DESCRIPTIVE REPORT

Type of Survey Hydrographic
Field No. RA-10-15-98
Registry No. H-10838

State Alaska
General Locality Southwest Prince William Sound
Sublocality Disk Island to Point Eleanor

Descriptive Report to Accompany Hydrographic Survey H-10838

Detail area of AWOIS item 52307.

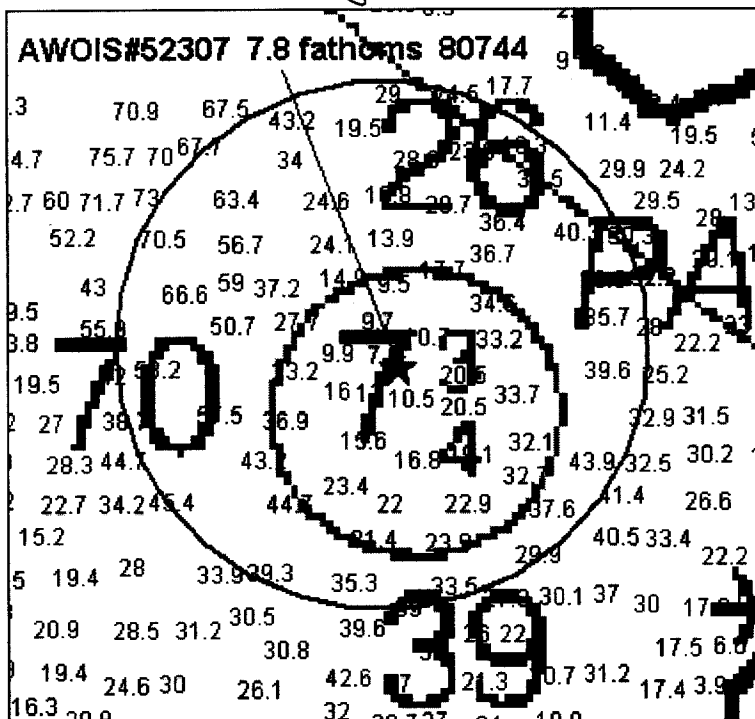
Hydrographer recommends removing the Position Approximate (PA) designation and charting the area as surveyed. Chart 8 Fm Sounding from present survey

Detail Area of AWOIS item 52311.

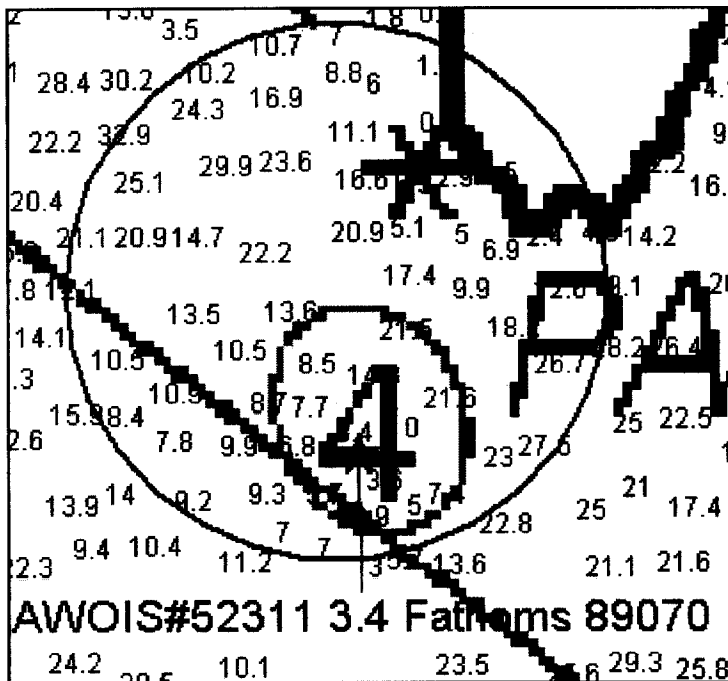
Hydrographer recommends removing the 4 fathom (PA) and charting of the area as surveyed. Concur
 Chart 3 4 Fm Sounding from present survey.

Detail area of AWOIS item 52312

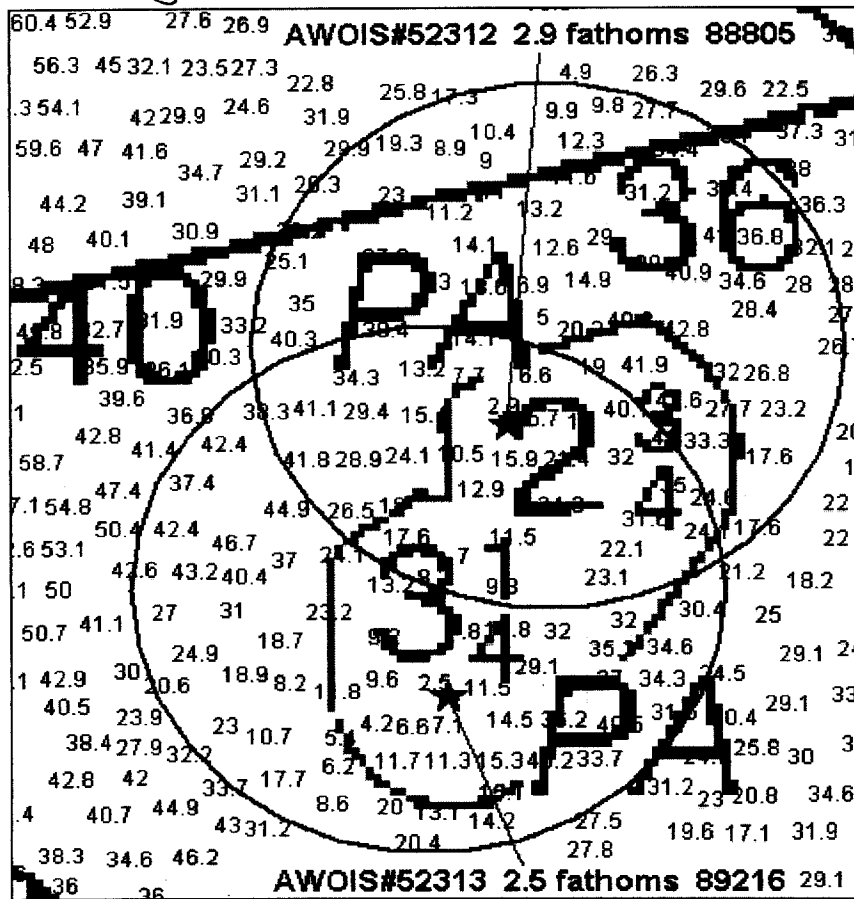
Hydrographer recommends removing the 2 3/4 fathom (PA) and charting the area as surveyed. Concur
Chart 2 3/4 Fm Sounding from present survey.

Detail area of AWOIS item 52313.

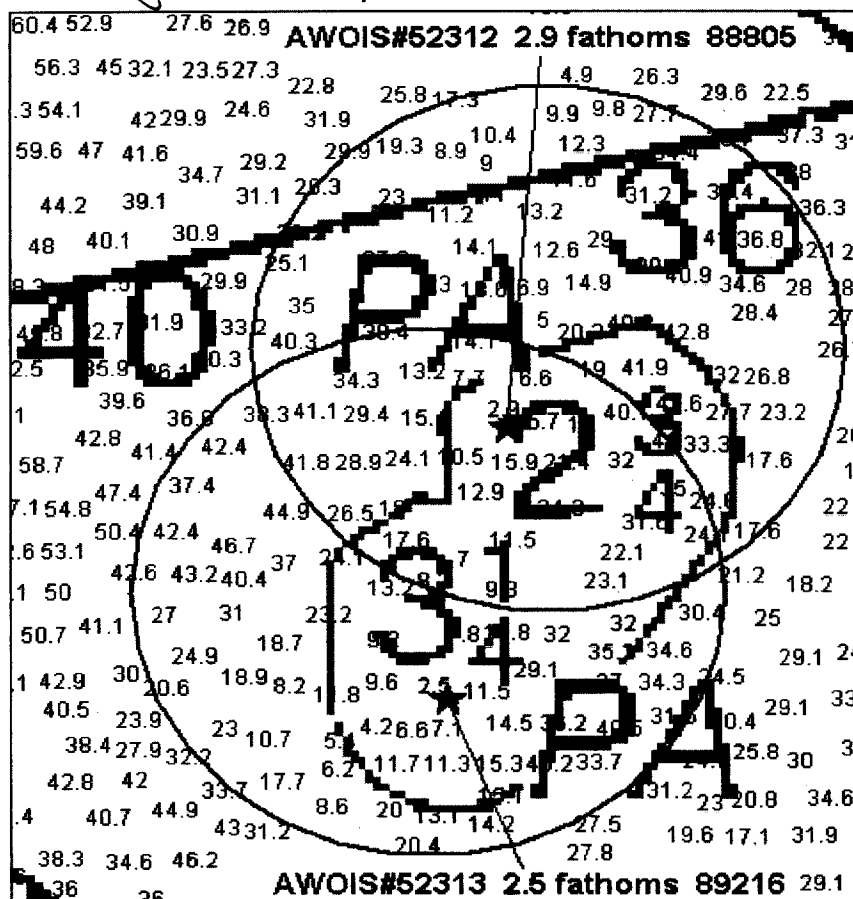
Hydrographer recommends removing the 3 ¼ fathom (PA) and charting the area as surveyed. Concur
 Chart 2 ¼ Fm Sounding From present Survey.
